**Docket Number:** NG23-015  
**Subject Matter:** First Data Request  
**Request to:** NorthWestern Energy (NorthWestern or Company)  
**Request from:** South Dakota Public Utilities Commission Staff  
**Date of Request:** September 8, 2023  
**Responses Due:** September 14, 2023

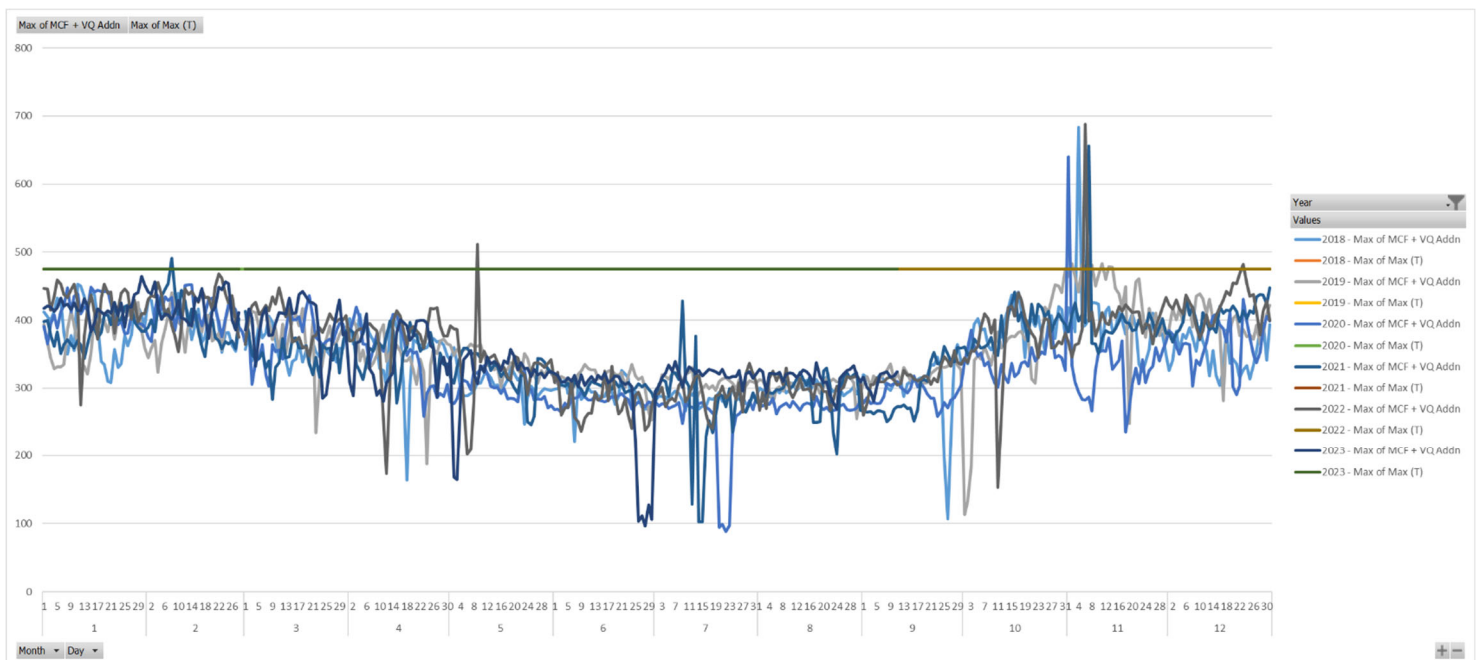
1-2. How often does NorthWestern anticipate Valley Queen will be interrupted?

Based on data collected since 2018, NWE estimates that 9% of the time, there is a risk to Valley Queen (VQ) of partial or total curtailment based on conditions on the transmission system feeding Milbank. The chart below shows the at-risk period. This period is any point where the new load from VQ, plus the historic use at any given time is greater than the known historical flow amount at the tap. Above this amount, ability to transmit gas to Milbank will be determined by multiple other loads on the line, which may or may not result in VQ being curtailed. It is important to note that this improvement project is to mitigate shortfalls in the capability of the Milbank distribution system to transport gas from the TBS to the VQ plant. These shortfalls need to be addressed for VQ to grow, whether their growth is firm or interruptible. This project does not address the transmission system, which is expected to be the driver of curtailment.

*\*note: this chart represents the maximum hourly flow/day. Because of the large quantity of data points, showing every hour on this chart is not feasible. There may be multiple at risk hours in each day.*
